REMARKS

YOR920030479US1 Serial No. 10/717,737

AMENDMENTS TO THE DRAWINGS:

FIG. 3J

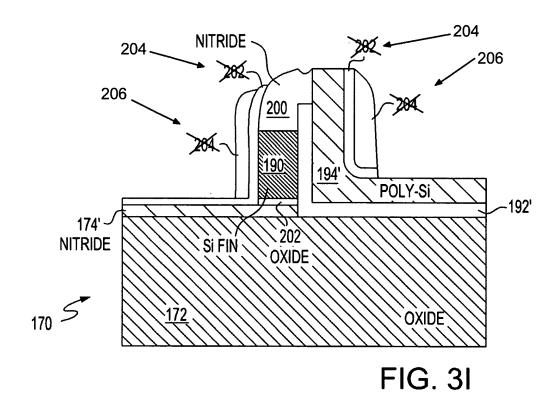
Figure 3K is objected to because "202" designates two different elements. Upon review of Figure 3K, applicants noticed that one instance of 202 had, inadvertently, labeled the "thin gate dielectric 204" as described in paragraph 0027. Applicants also noticed that this typographical error in Figure 3K was also included in Figures 3I and J. Further, applicants noted that "polysilicon spacers 206" had been inadvertently labeled 204 in Figure 3I. Accordingly, replacement sheets including Figures 3I – K are included herewith. Annotated sheets showing changes follow the replacement sheets. Reconsideration and withdrawal of the objection to the drawings is respectfully solicited.

The attached two (2) sheets of drawings include changes to Figures 3I – K. These 2 sheet, which include Figures 3I – K, replace the original sheets 12 and 13 including Figures 3I – K. Two (2) annotated sheets showing changes follow the replacement sheets.
